Proposed Site Plan Modifications for
Convoy Supply, Inc
 5804 204th Street SW Lynnwood, Washington

LANDSCAPE PLAN
 LANCE MUELLER & ASSOCIATES
 ARCHITECTS
 130 LAKESIDE • SUITE 250 • SEATTLE, WA 98122 • (206) 325-2553

sheet
L-1

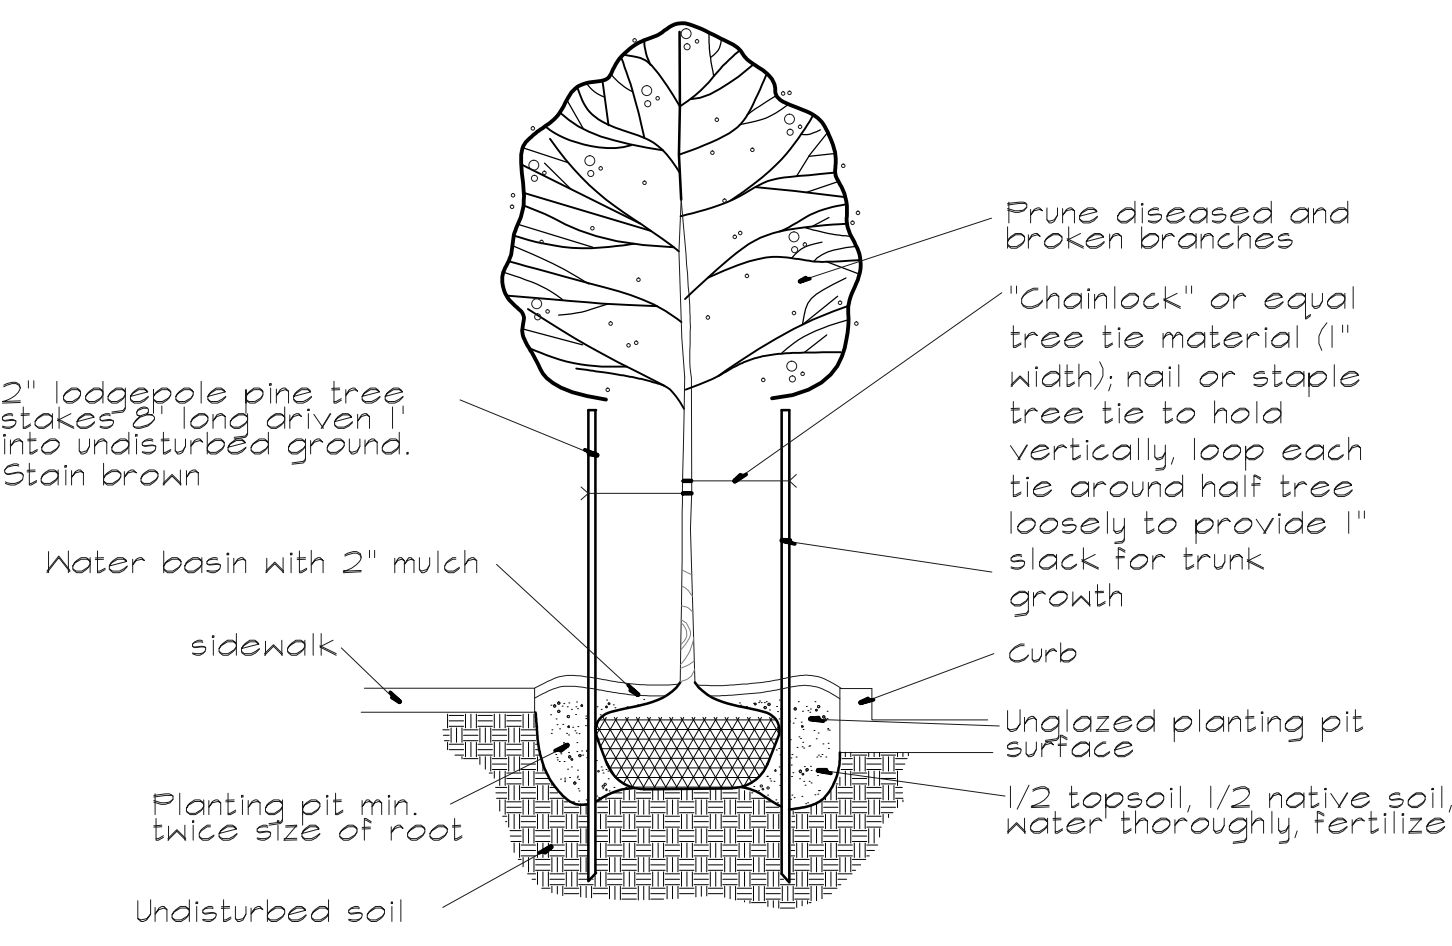
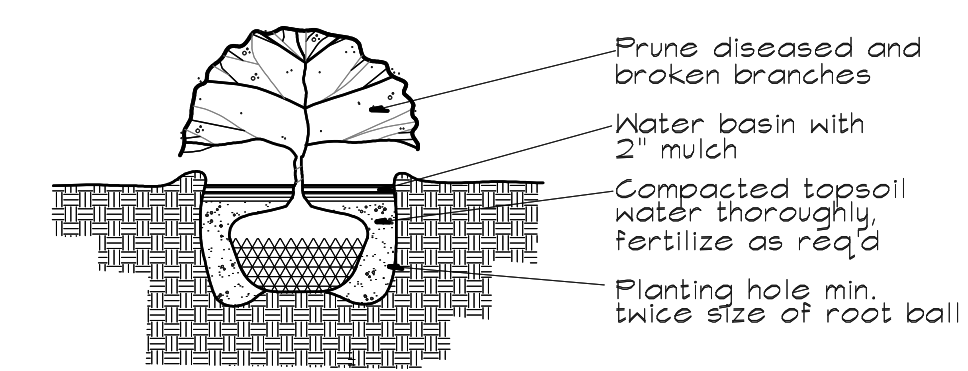
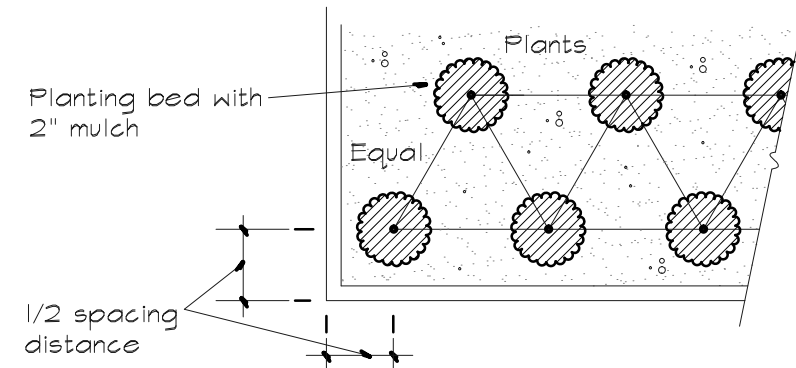
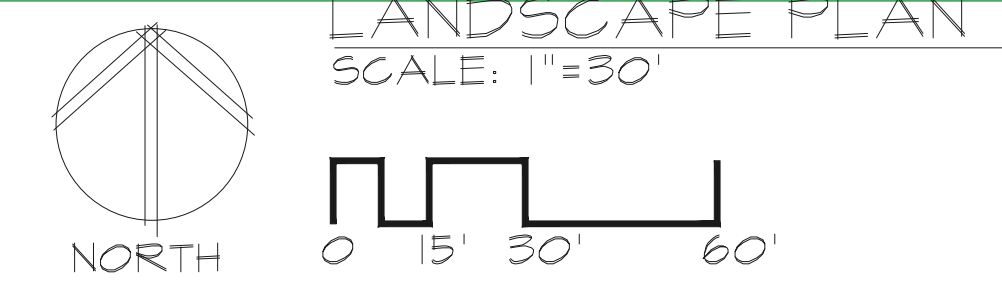
CORRECTION:
Per submittal checklist, must provide a summary table demonstrating how the proposed landscaping plan complies with LMC 21.08 Landscaping (refer to checklist for all missing information).
